Access Compliance Report

Public Rights-of-Way

(Curb Ramps)

Intersection ID: 27461	Main Street: BRUSH_HOLLOW_RD	Cross Street: FAWN_HILL_RD	Location: E
ADA ID: 440E01D70906	Ramp Type: PerpDiag	Initial Pass/Fail: Fail	Overall Compliance: No
Severity Score: 10			
Codes/Mitigation Info/Possible Solution		Field Measurements/Component Compliance

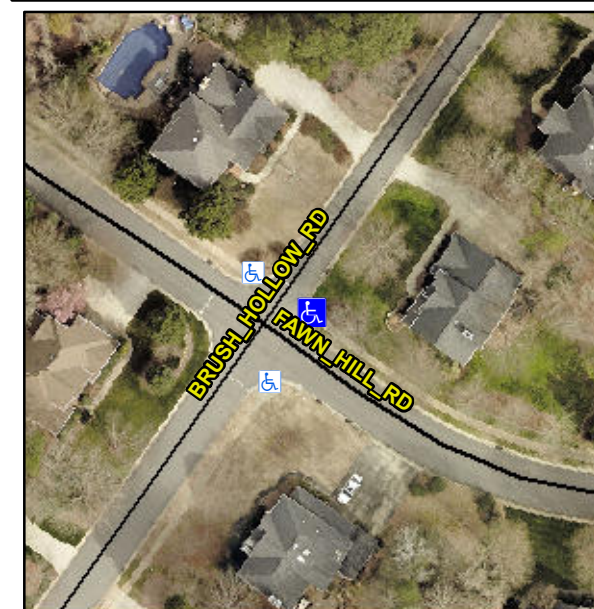
Not Found, R304.5.1, R304.5.3

Compliance	Description	Data	Compliance	Description	Data
N/A	Ramp Length (in)	49.0	Yes	Ramp Slope (%)	5.0
No	Ramp Width (in)	47.0	No	Ramp XSlope (%)	2.2
N/A	Flare Type LT	N/A	N/A	Flare Type RT	N/A
N/A	Flare Slope LT (%)	N/A	N/A	Flare Slope RT (%)	N/A
N/A	Flare Traversable LT?	N/A	N/A	Flare Traversable RT?	N/A
N/A	Landing Length (in)	N/A	N/A	DWS Provided?	N/A
N/A	Landing Width (in)	N/A	N/A	DWS Contrast?	N/A
N/A	Landing Slope (%)	N/A	N/A	DWS Length (in)	N/A
N/A	Landing X Slope (%)	N/A	N/A	DWS Full Width?	N/A
N/A	Landing Curb? (Y/N)	N/A	N/A	DWS Offset (in)	N/A
N/A	Shared Landing?	N/A			
N/A	Gutter Ponding?	N/A	N/A	Gutter Slope (%)	N/A
N/A	Gutter Lip Ht (in)	N/A	N/A	Gutter X Slope (%)	N/A
N/A	Painted X Walk1?	No	N/A	Painted X Walk2?	No
	X Walk 1 Direction	To NW		X Walk 2 Direction	To SW
N/A	X Walk 1 Width (in)	N/A	N/A	X Walk 2 Width (in)	N/A
	X Walk 1 Slope (%)	1.7		X Walk 2 Slope (%)	0.5
	X Walk 1 X Slope (%)	1.3		X Walk 2 X Slope (%)	3.4

Remove & Replace Curb Ramp With Two New Directional Ramps or Equivalent.
